REMARKS

Amendments to the Drawings:

FIG. 10A

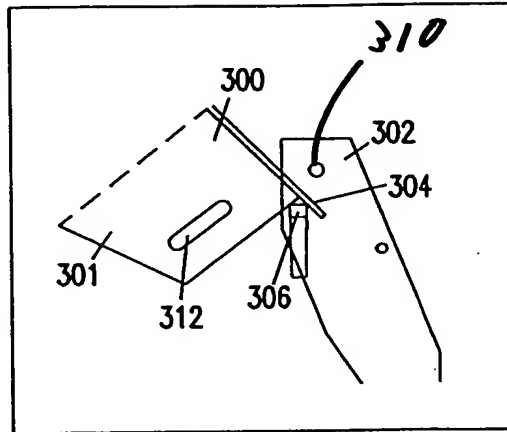
The drawings stand objected to on the grounds that certain reference numbers are not present in the drawings. Page 10 of the specification has been amended so that reference number "46" has been replaced with reference number "406." The reference number 168 is present in Figure 6. The reference numbers 310 and 454 are now present in amended Figures 10A and 12A, respectively. Enclosed with this amendment are replacement sheets including amended Figures 10A and 12A and annotated sheets showing the changes to Figures 10A and 12A.

The attached sheets of drawings include changes to Figures 10A, 11, and 12A. These sheets, which include Figures 10A-10D, 11, and 12A-12B, replace the original sheets including Figures 10A-D, 11, and 12A-B. In Figure 10A, the previously omitted reference number 310 has been added. In Figure 11, a line has been removed. In Figure 12A, the previously omitted reference number 454 has been added.
